Technical Service Bulletin

Topic	93 e-tron update OBC software when replacing HV wiring harness for charging socket - NTC to PT1000 charging socket
Market area	United States 444 Volkswagen of America, Inc. (6444)
Brand	Audi
Transaction No.	2070110/6
Level	EH
Status	Released for publishing
Release date	May 1, 2025

Figure 1. High-voltage wiring harness for charging socket.

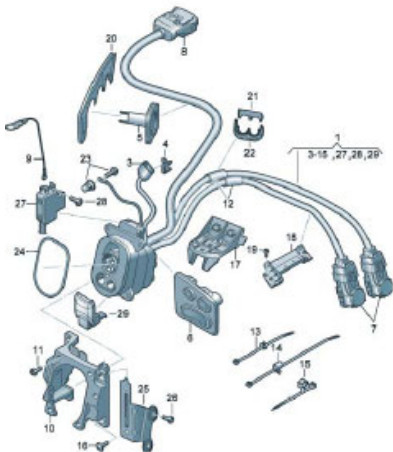
The High Voltage Wiring Harness for the charging socket UX4 or UX5 is replaced as part of any repair work (Figure 1).

The charging socket was modified in production.

From Q2 2020, only the new-generation high-voltage wiring harness for the charging socket is fitted in production vehicles.

It is essential to check the part number of the removed original high-voltage wiring harness and of the new replacement high-voltage wiring harness.

If the high-voltage wiring harness for the charging socket is replaced as listed in Table 1.2, an SVM code will need to be performed, *and a replacement test plan performed.*
